FIRE SAFETY INSPECTION REPORT

**VINTAGE DENIM STUDIO LTD.
PLOT 99 AND 102-128, ISHWARDI EPZ, ISHWARDI,
PABNA**

ACCORD
on Fire and Building Safety in Bangladesh

June 1, 2014

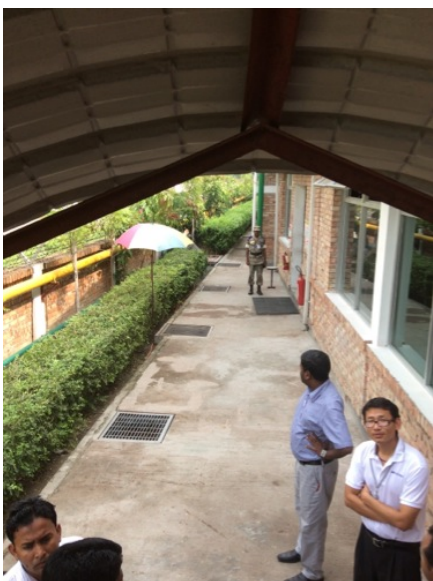
F-5	Fire Rated Construction	The exit stairs and ramp in assembly building are not separated from other spaces on each floor by fire-rated construction.	Provide minimum 1.5-hr fire rated doors and seal all unprotected openings to separate the exit stairs from work areas and other building spaces on all floor levels. Ensure that the fire doors are self-closing and positive latching and that they are provided with fire exit (panic) hardware where serving production floors.	Within 3 months
			If fire doors are required to be held open for functional reasons, provide automatic-closing devices tied to the fire alarm system.
